Nozzle N7 LBO reflux 2" touch with column .

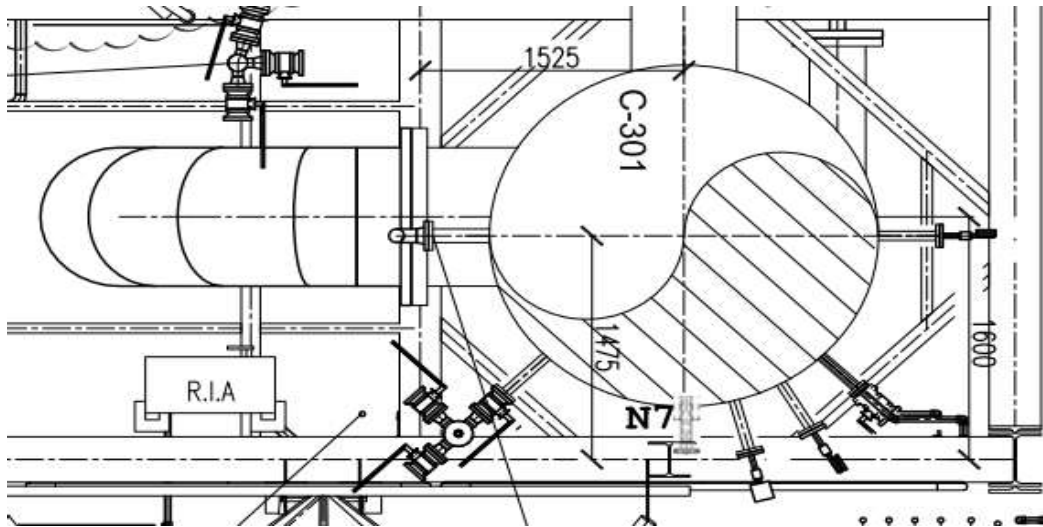
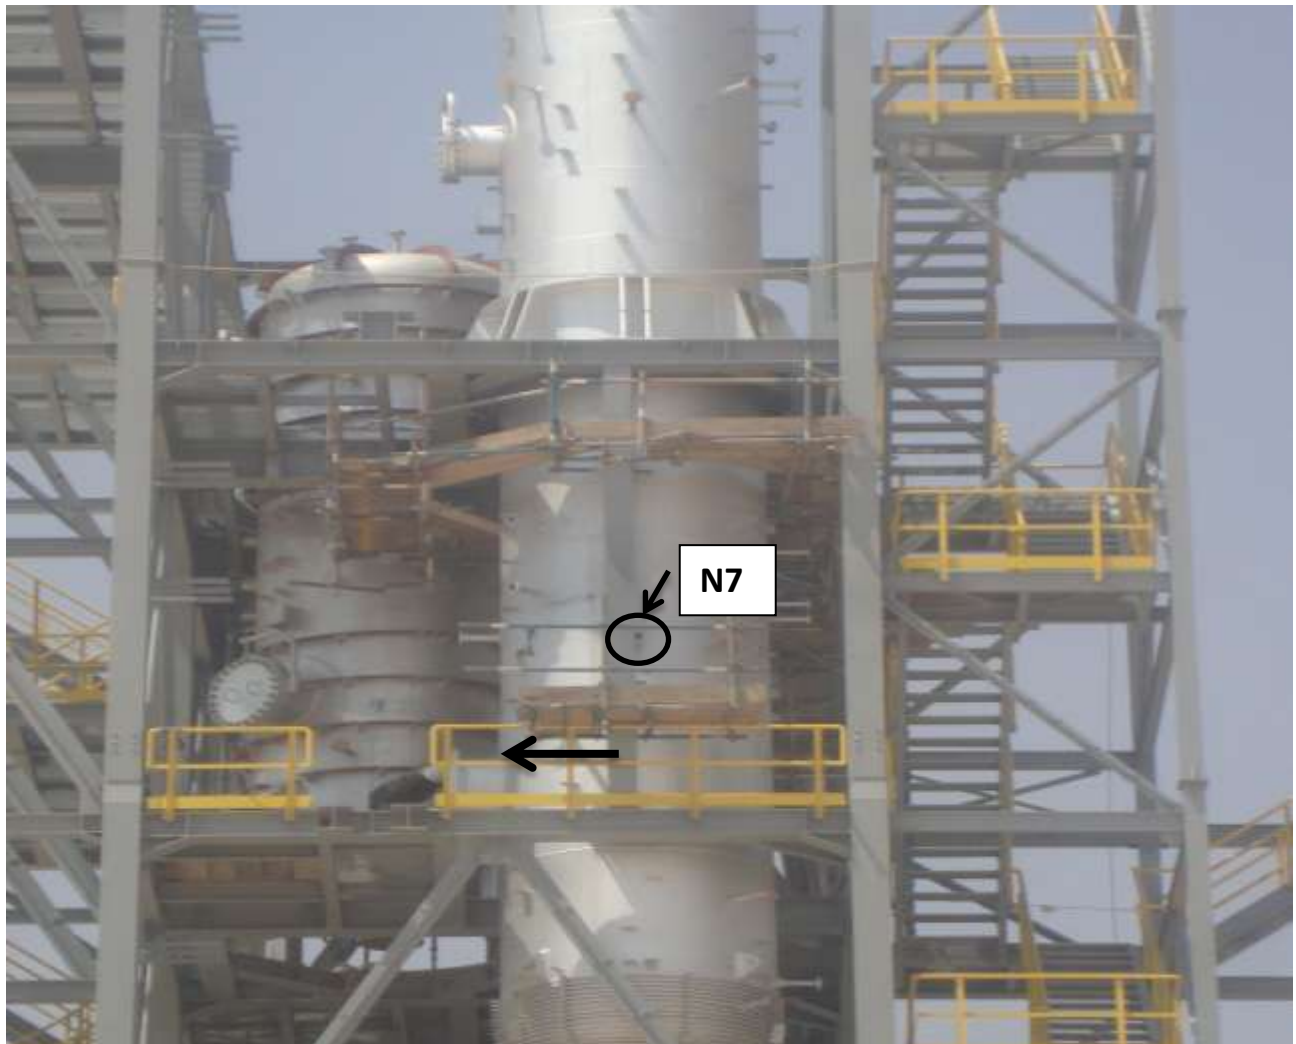
the actual orinetation is about 80degree ..and it should be 90 deg.so we need to rotate about 10 deg more to the same clockwise direction.

Can we cut this nozzle in the center but our wondering if we need to redo hydrotest later ?

Or also can we shifting the column itself by 10 to 15 cm to the south as it indicated by the arrow
